SUBJECT: AMENDMENT NO. 83 TO FACILITY OPERATING LICENSE NO. NPF-30
(TAC NO. M82627)

CALLAWAY PLANT, UNIT 1

AMENDMENT TO FACILITY OPERATING LICENSE

ATTACHMENT TO LICENSE AMENDMENT NO. 83

**FIGURE 3.4-4
 MAXIMUM ALLOWED PORV SETPOINT
 FOR THE COLD OVERPRESSURE MITIGATION SYSTEM**

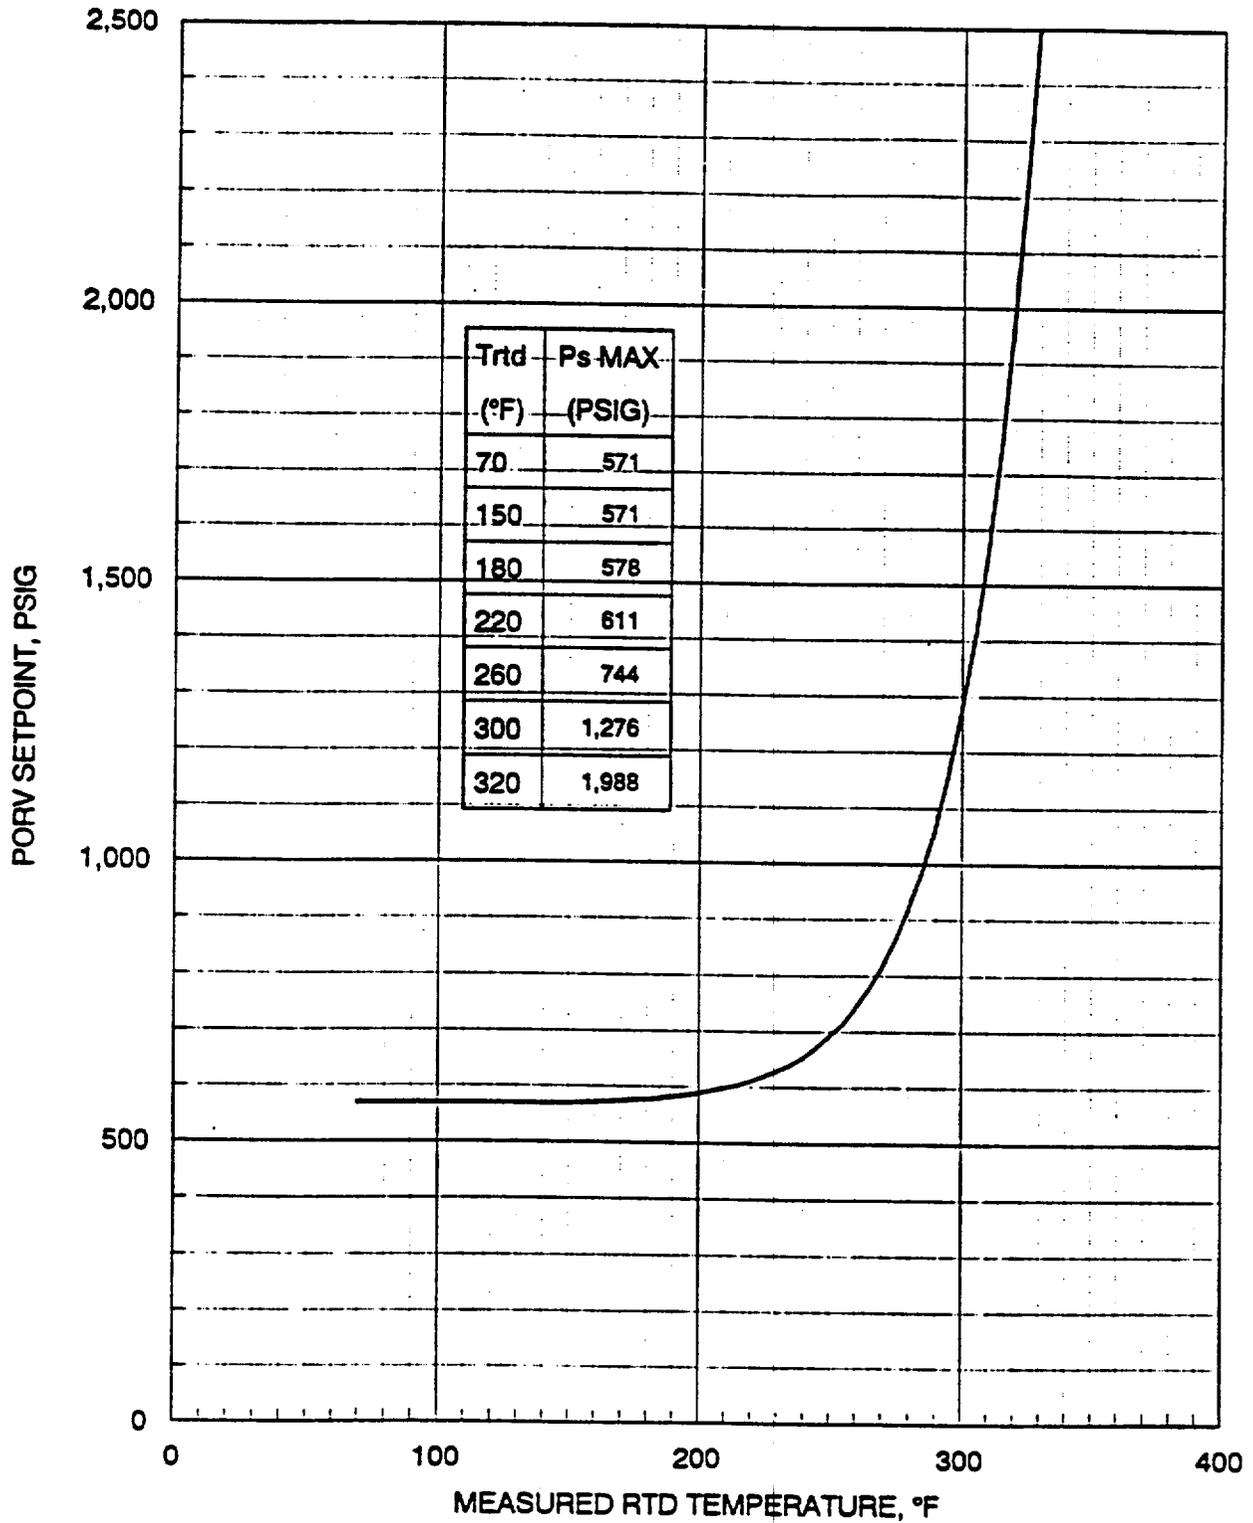
- a. Two residual heat removal (RHR) suction relief valves each with a Setpoint of 450 psig \pm 3%, or
- b. Two power-operated relief valves (PORVs) with Setpoints which do not exceed the limit established in Figure 3.4-4, or
- c. One RHR suction relief valve and one PORV with Setpoints as described above.

The Maximum Allowed PORV setpoint for the Cold Overpressure Mitigation System will be updated based on the results of examinations of reactor vessel material irradiation surveillance specimens performed as required by 10 CFR Part 50, Appendix H.
